PROJECT: Valley Vista 1.3 Residential Development - Update #1
Project in CNLV for Concurrence

CITY OF LAS VEGAS INTER-OFFICE MEMORANDUM		DATE: February 3, 2021
TO: Land Development Services Department of Building & Safety		FROM: Albert Sung, P.E. Flood Control Project Engineer Department of Public Works
SUBJECT: Drainage Study for: Valley Vista 1.3 Residential Development – Update #1 - Project in CNLV for CLV concurrence		COPIES TO: Triton Engineering
Cross Streets:	NEC of Decatur Boulevard & Farm Road	DR Horton
File Number:	F:\Depot\DSMemos\DS5375B.doc	Bart Anderson, P.E., DevCo
Parcel Number:	124-18-210-001	CNLV
Zoning Action:	N/A	
FEMA Flood Zone	YES NO X	
Proposed Storm Drain	YES NO X

**RE: Update to the Technical Drainage Study for Valley Vista 1.3, Residential Development
CNLV #395-2020**

**Subject: Update #1 to the Technical Drainage Study for Valley Vista Parcel 1.3
CNLV #165-2020**

SHEET
11
OF 31

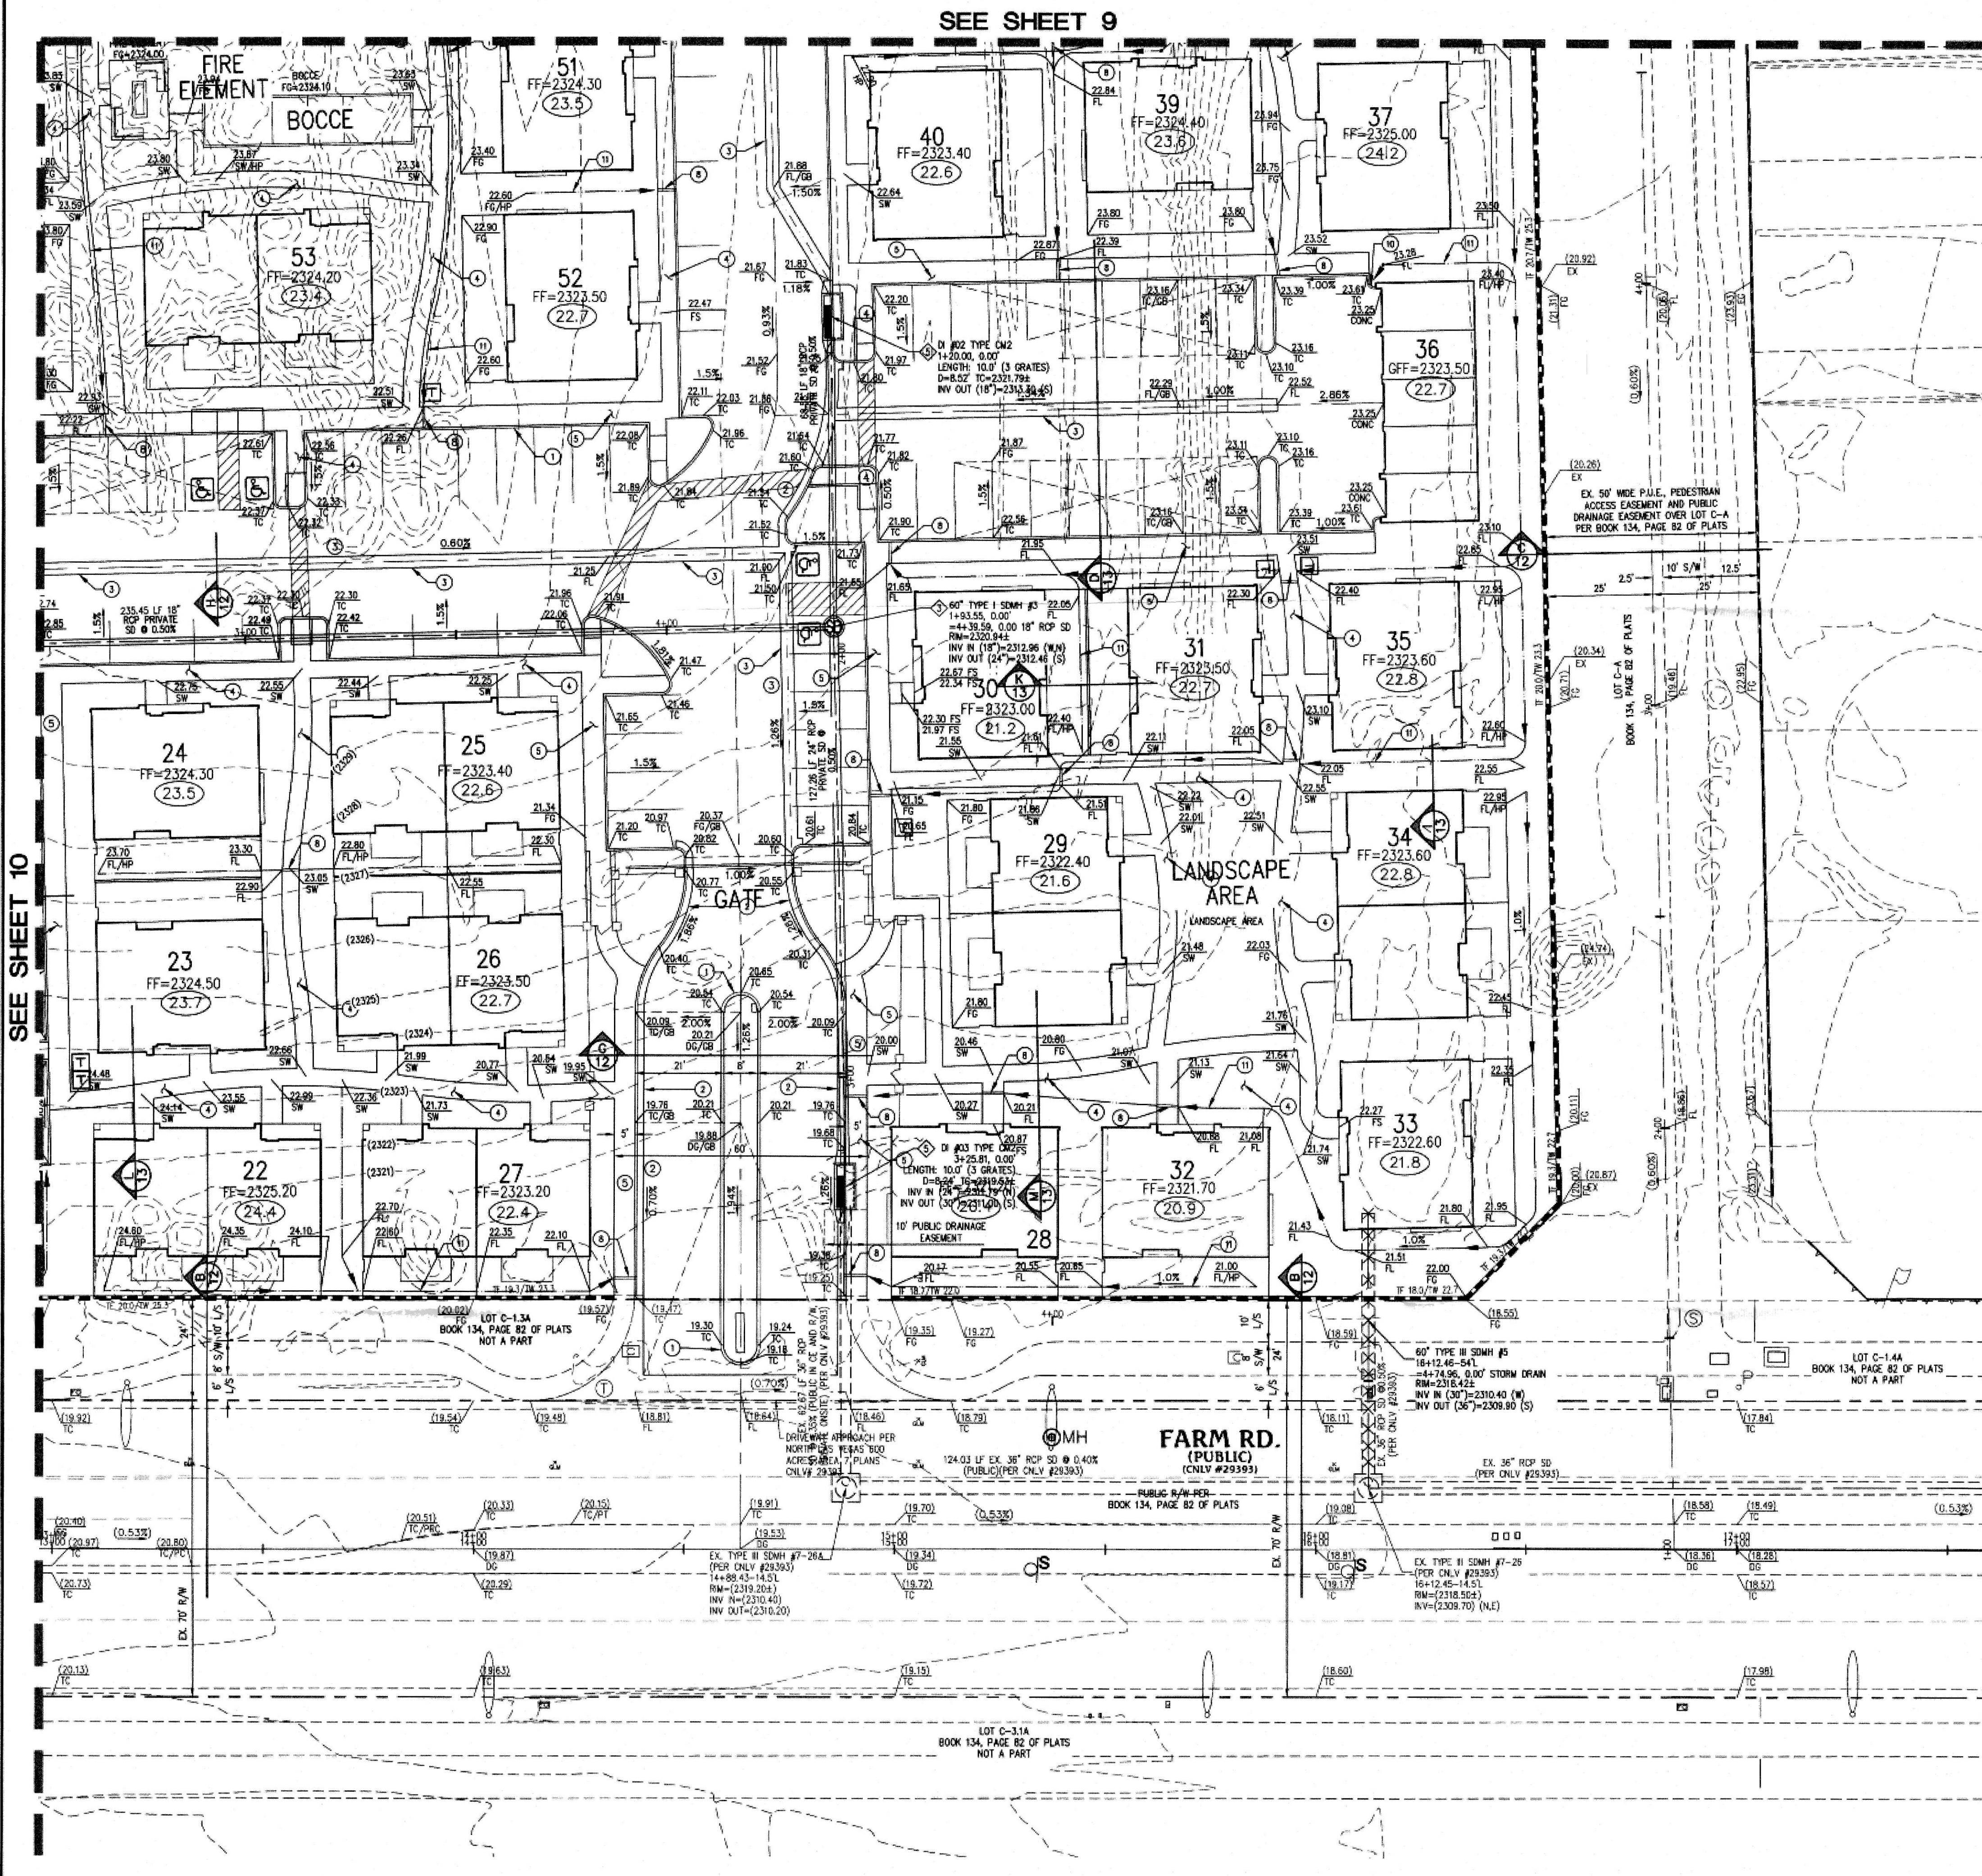
6. The size and slope of the RCP pipe between DI #03 and SDMH No. 7-26A is called out on the Grading Plan, Sheet 11, as 36-inch with a slope of 1.35%. The pipe size and slope called out on the Plan and Profile on Sheet 15 is 30-inch and 1.42%. Please review and revise Sheet 11 and Sheet 15 accordingly
